# Recall Bulletin

## PRODUCT SAFETY RECALL

**SUBJECT:** BODY WIRING HARNESS CHAFING

**MODELS:** 2003-2005 CHEVROLET KODIAK  
 2003-2005 GMC TOPKICK  
 EQUIPPED WITH AIR BAGS (RPO AJ3 OR AK5)

892052

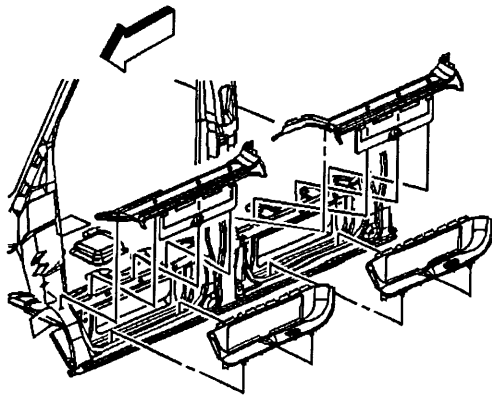
2. Gently pull the left hinge pillar trim panel in order to release the retaining clips.
3. Remove the left hinge pillar trim from the vehicle.
4. Inspect the hinge pillar trim panel for proper placement of the retaining clips.

823442

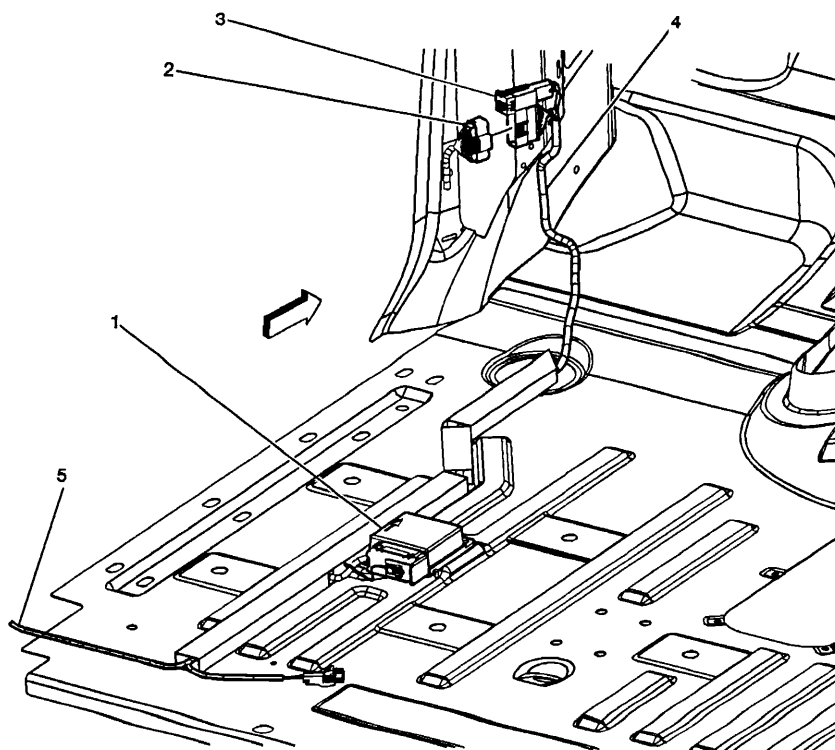
5. Firmly grasp the door sill plate.
6. Gently pull upwards to release the retaining clips.
7. Inspect for any missing or broken clips and replace as necessary.
8. Fold back the floor mat and tuck it under the brake pedal.
